project **21 THE BEECHES**
LYDIARD MILLCENT
NEAR SWINDON
WILTS.
SN5 3LT

title **PROPOSED EXTENSIONS AND ALTERATIONS.**
FIRST FLOOR PLAN AND SECTION.

revision	no.
A	Y26-105-4

PROPOSED FIRST FLOOR PLAN

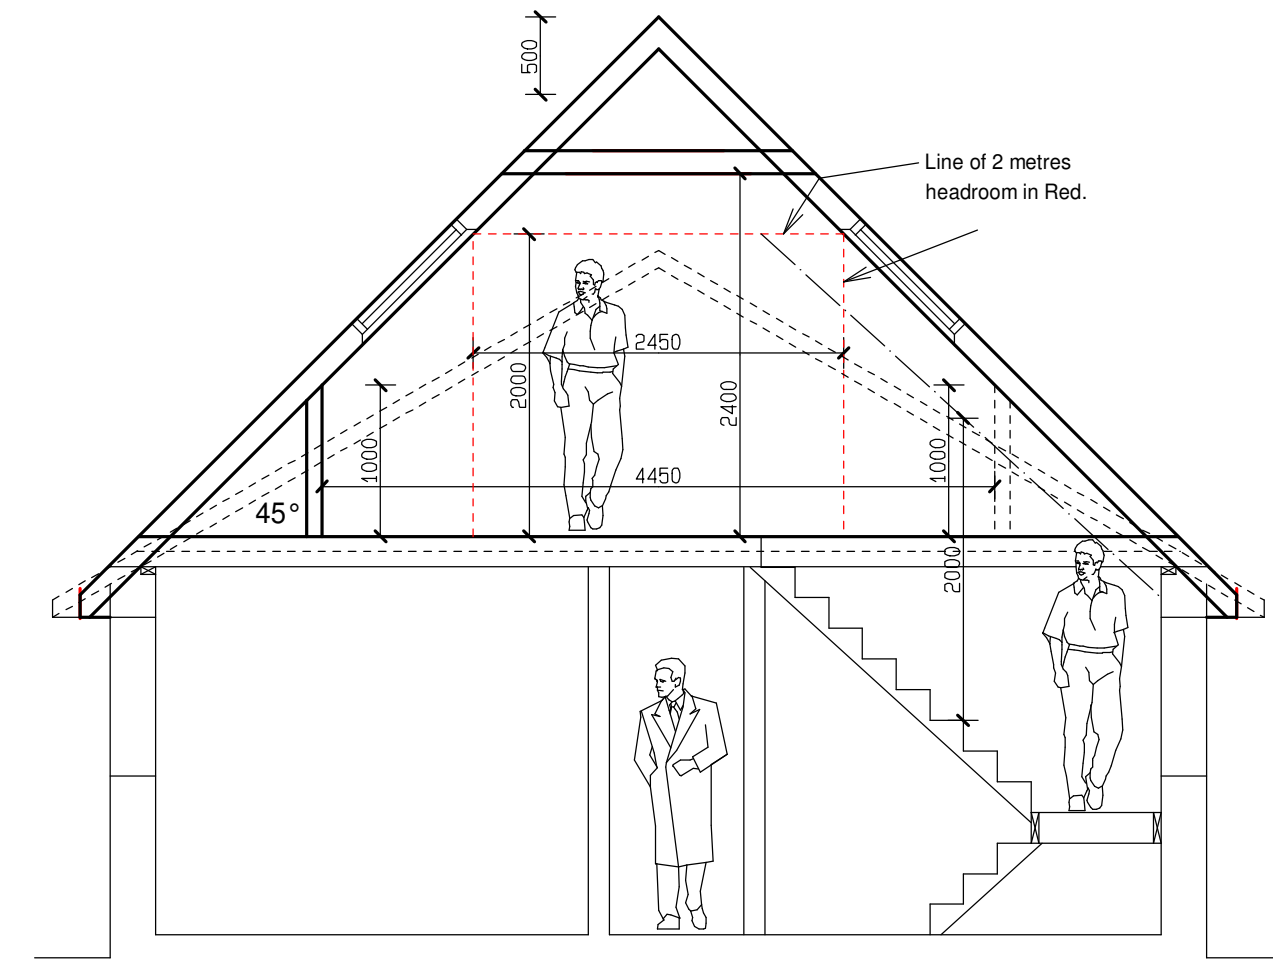
Revision A 8-7-2026
Ramp adjacent to front door added to floor plan as previously omitted in error.
All velux roof lights have been numbered to the first floor plan and the proposed elevations.
The flat roof of the single storey side extension has been reduced in height to match the eaves line of the main roof.
The Ridge height of the roof over the proposed dressing room has been reduced in height by 500mm. All as required by the appointed planning officer.
A window has been added to the front gable (first floor bedroom) to comply with the fire escape regulations for bedroom escape windows. This was omitted from the first scheme in error.
